ADDENDUM No. 5

Project	T.A. Blakelock H.S. Renovations - Phase 1	Project No.	2215A
Location	1160 Rebecca Street, Oakville, Ontario	Date of Issue	2023 04 04
Owner	Halton District School Board	File	2215/7.1.3

STRUCTURAL ADDENDUM No. 1

Drawing Title: LEVEL 0 REFLECTED **CEILING PLANS AND DETAILS**

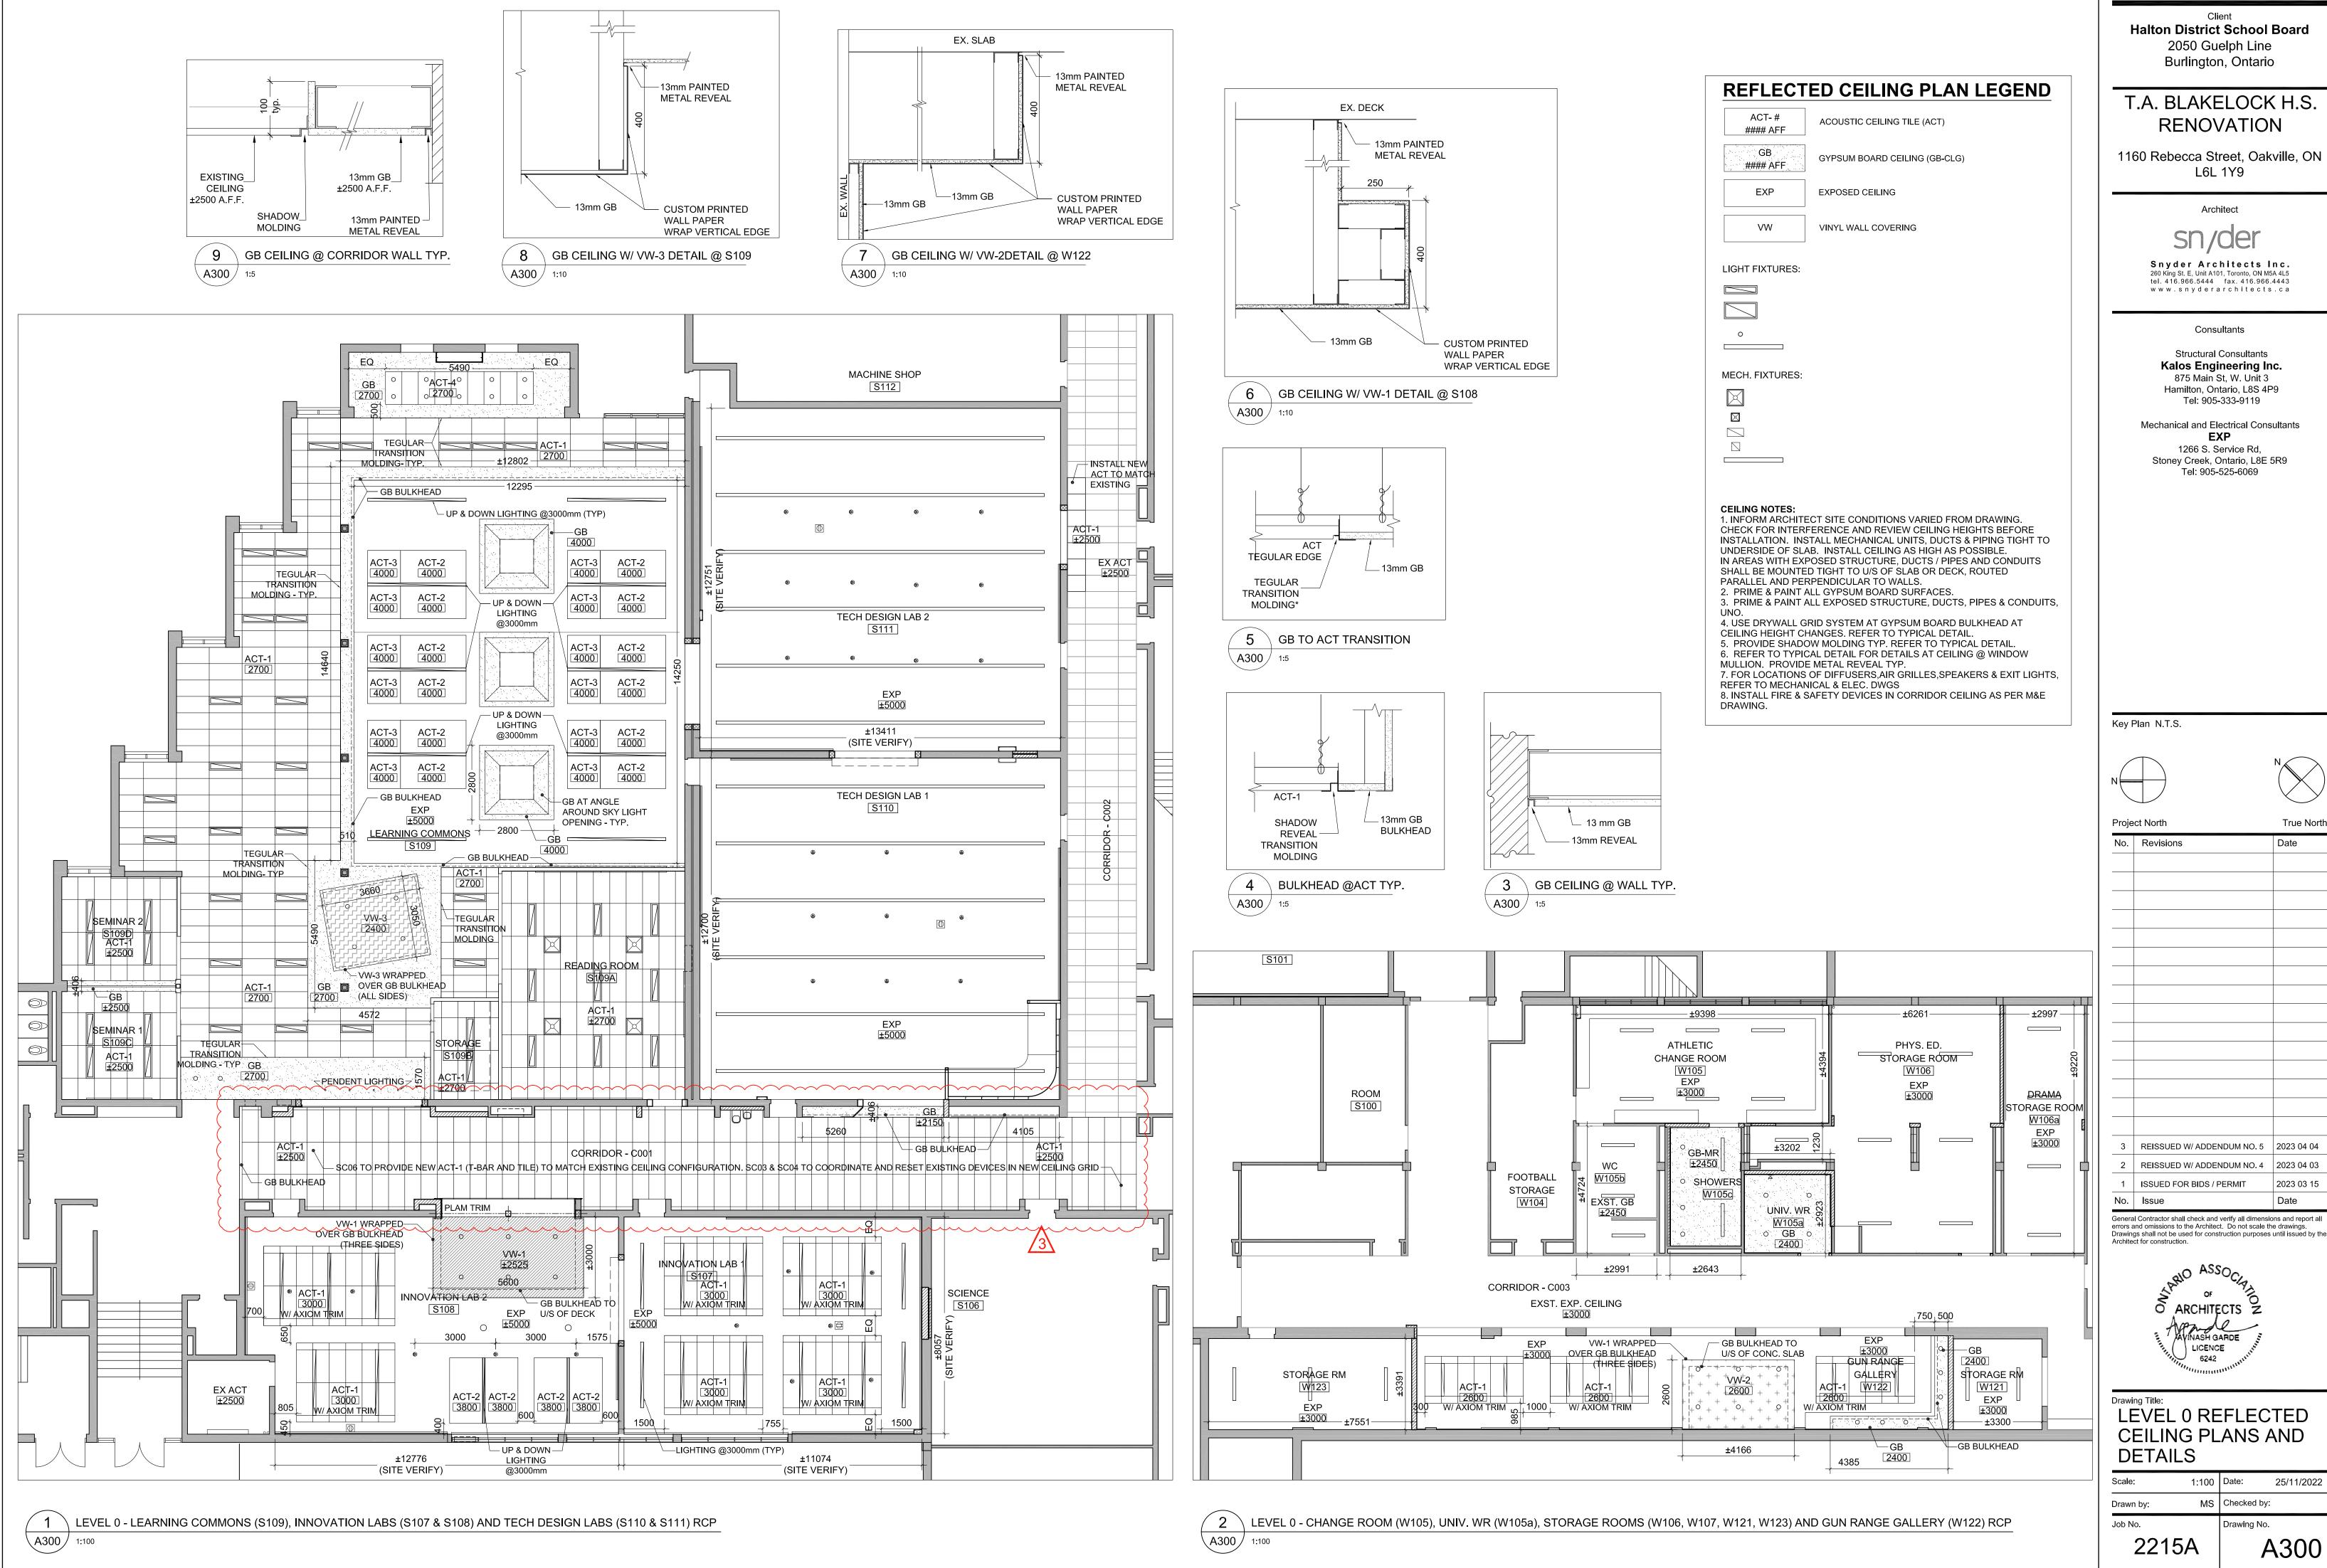
A5-3 DRAWING NO. 300 LEVEL 0 REFLECTED CEILING PLANS AND DETAILS (reissued)

- .1 Replace drawing with the attached Revision No. 3.
- .2 Revisions include the following:
 - .1 Corridor C001 ACT & Gypsum board ceiling extent.

DOOR SCHEDULE AND **DOOR & SCREEN TYPES** & DETAILS

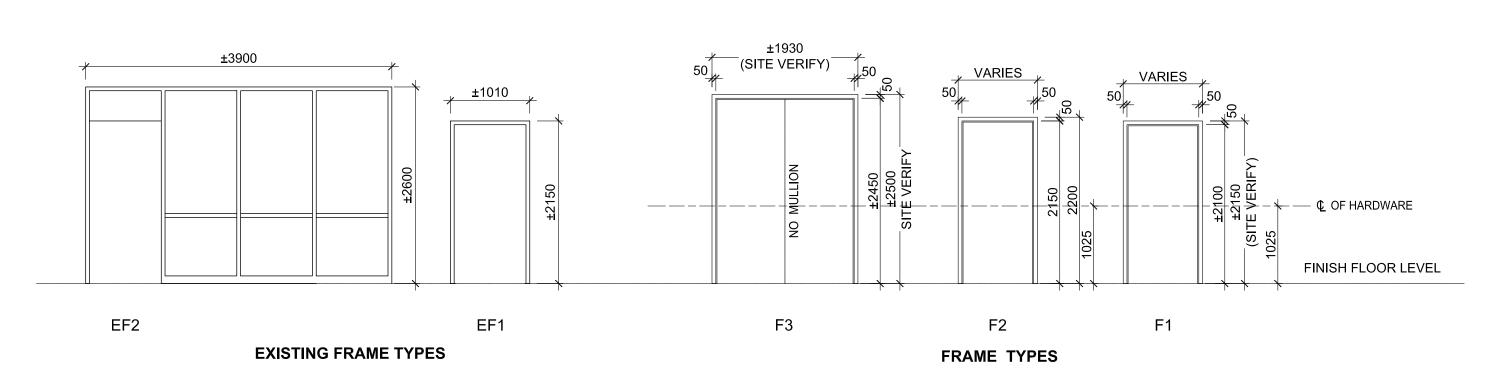
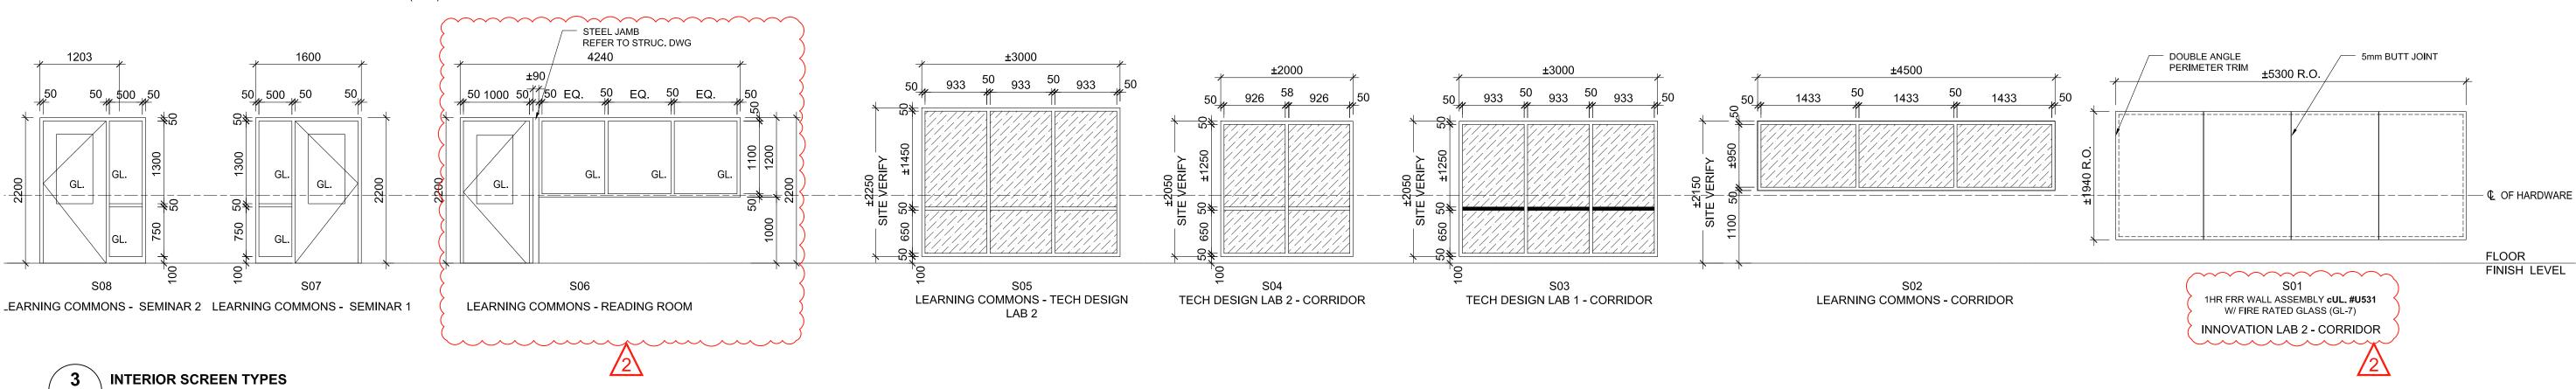
A5-4 DRAWING NO. 900 DOOR SCHEDULE AND DOOR & SCREEN TYPES & DETAILS (reissued)

- .1 Replace drawing with the attached Revision No. 2
- .2 Revisions include the following:
 - .1 Revise Screen 'S06' as shown to accommodate new steel post between door & screen frame as per Structural Addendum No. 1
 - .2 Replace 'GL-01' with 'GL-7' in Screen 'S01'
 - .3 Replace 'FG-C' with 'GL-3'
 - .4 Replace 'FG-E' with 'GL-6'

- .5 Replace 'SG-A' with 'SIG_CLR-1'
- .6 Door Frame & Screen Schedule Replace 'FG-C' with 'GL-3' and Replace 'FG-D' with 'GL6'
- .7 Door Frame & Screen Schedule Revise glazing type to 'GL-6' for Door no. 107, 108, 111

LEVEL 0 RENOVATION **PLANS**

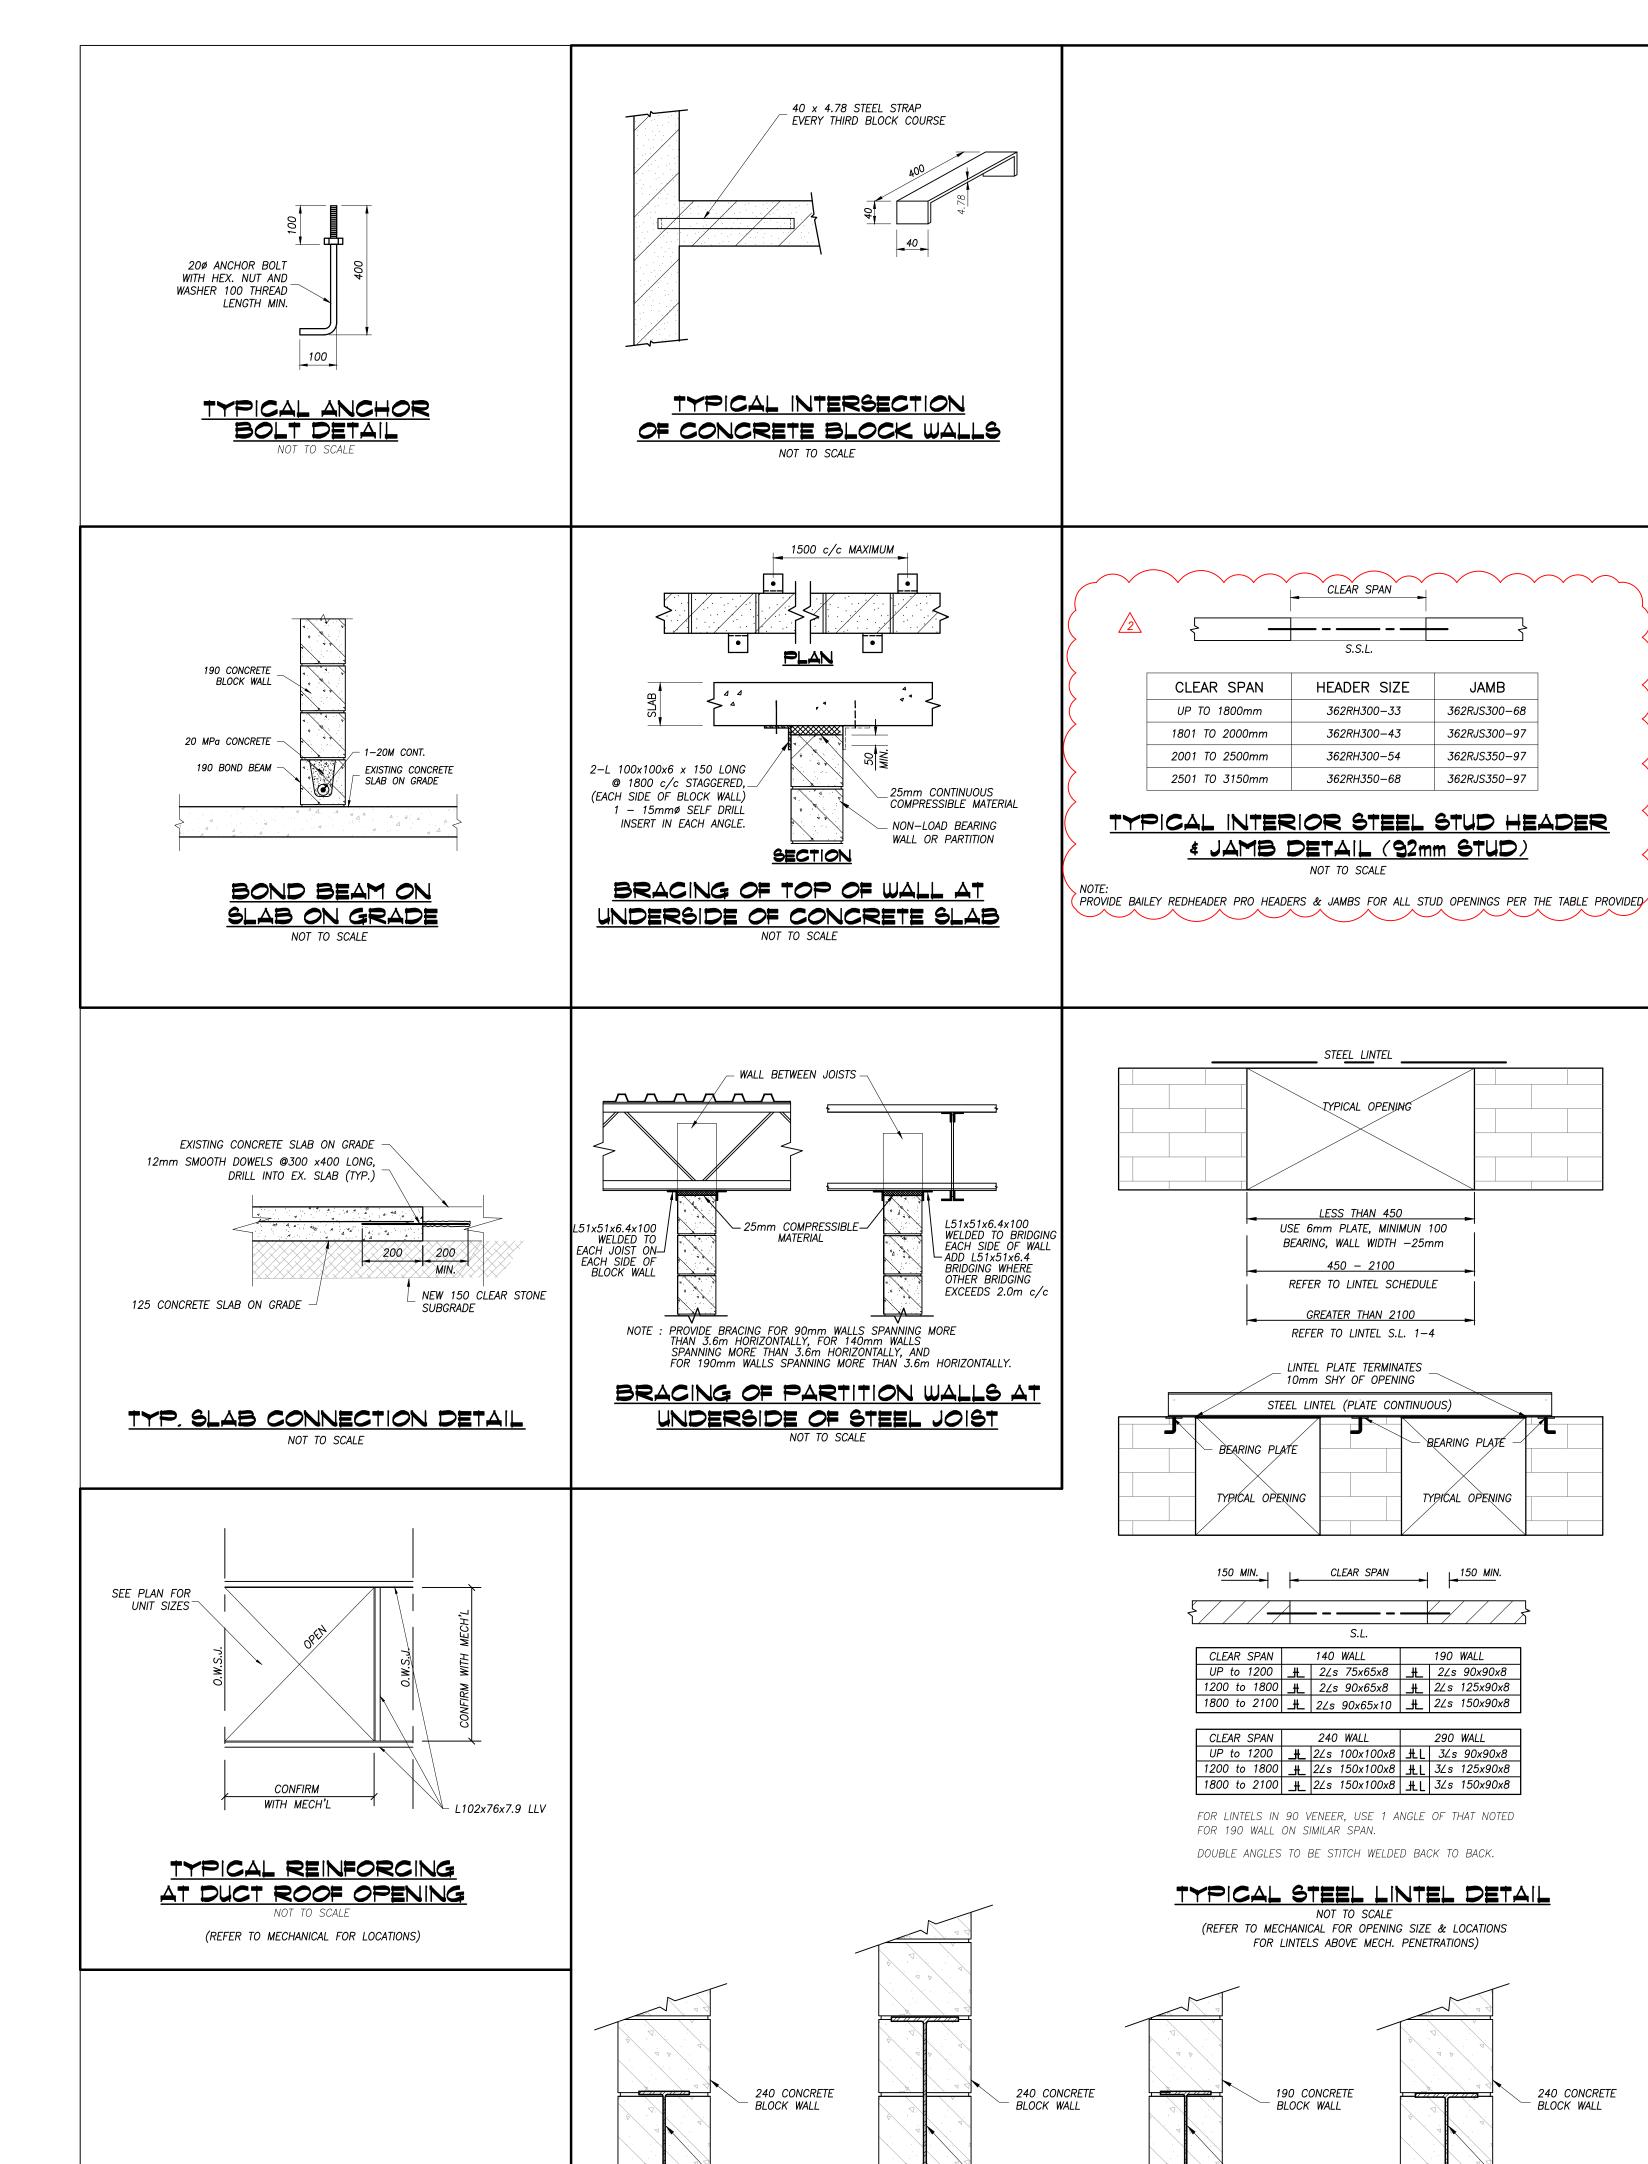
a. Curtain support framing added in Tech Design Lab S110
